Number: B106R1007-0

SERVICE BULLETIN

Ride: Z I P P E R

Subject: Seat Support Axle Inspection

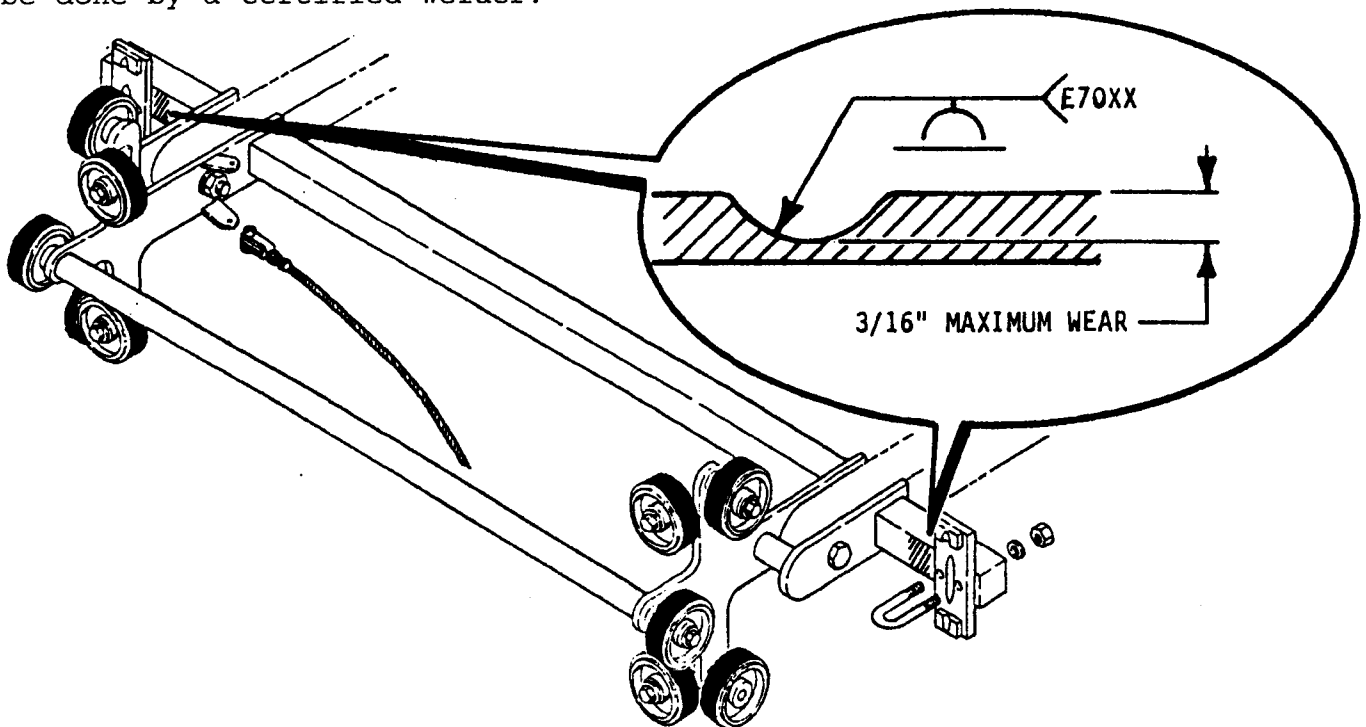
CHANCE RIDES, INC. has received reports from the field of wear on the seat support axle frame near the cable clamps on ZIPPER amusement rides. This wear is caused by occasional contact with the cable sheave during operation.

If the wear is no deeper than $3/16$ " , it can be corrected by grinding the worn area and welding the entire repaired area smooth as shown. All work must be done by competent, qualified mechanics, capable of understanding the function of the parts and their proper installation. All welding must be done by a certified welder.
